Well Name: BISTI COAL 19	Well Location: T25N / R12W / SEC 19 / SENE / 36.38882 / 108.14568	County or Parish/State: SAN JUAN / NM
Well Number: 1	Type of Well: OTHER	Allottee or Tribe Name:
Lease Number: NMNM25447	Unit or CA Name:	Unit or CA Number:
US Well Number: 300452814200S1	Well Status: Gas Well Shut In	Operator: DJR OPERATING LLC

Notice of Intent

Plug and Abandonment Procedure
for
DJR Operating, LLC
Bisti Coal 19 1
API # 30-045-28142
SE/NE, Unit H, Sec. 19, T25N, R12W
San Juan County, NM

BLM FLUID MINERALS Geologic Report

DJR Operating, LLC Current Wellbore Diagram

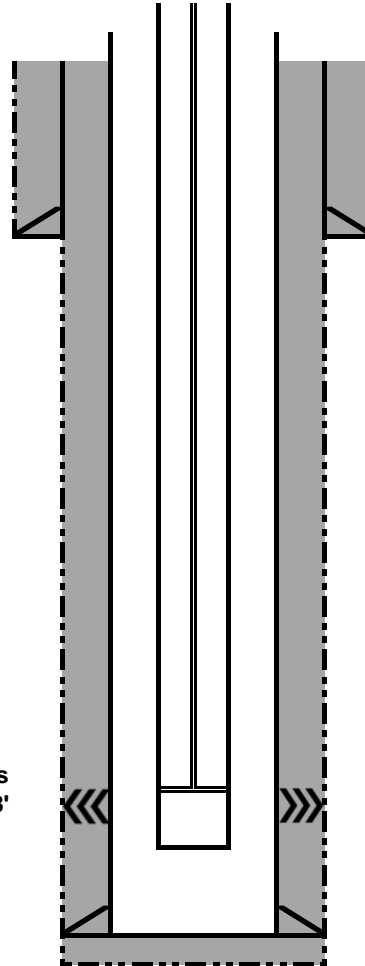
- No well log available for the subject well. BLM estimate for the Fruitland, Kirtland and Ojo Alamo formation top varies from operator's. No change required to the plugging plan as the well bore is proposed to be cemented from 1220' to Surface, covering all tops.
- Log analysis of reference well #2 indicates the Ojo Alamo sands investigated likely contain fresh water ($\leq 5,000$ ppm TDS). Plugging plan has cement from the cement retainer @ 1220' to Surface which will protect freshwater sands in this well bore.
- Fruitland coal perforations @ 1250'-1268'.
